Access Compliance Report Public Rights-of-Way (Curb Ramps)

Main Street: YORBA_LINDA_BLV D Cross Street: PALM_AVE Location: NW

ADA ID: RPAT220221102605 Ramp Type:Type 1 - Perpendicular Diagonal Initial Pass/Fail: Fail Overall Compliance: No Severity Score: 30

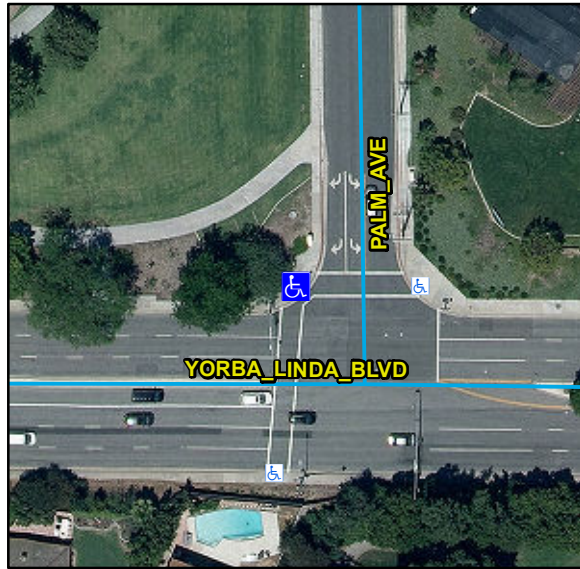
R304.2.2, R304.5.3, STD 1115

Remove & Replace Curb Ramp With Two New Directional Ramps or Equivalent.
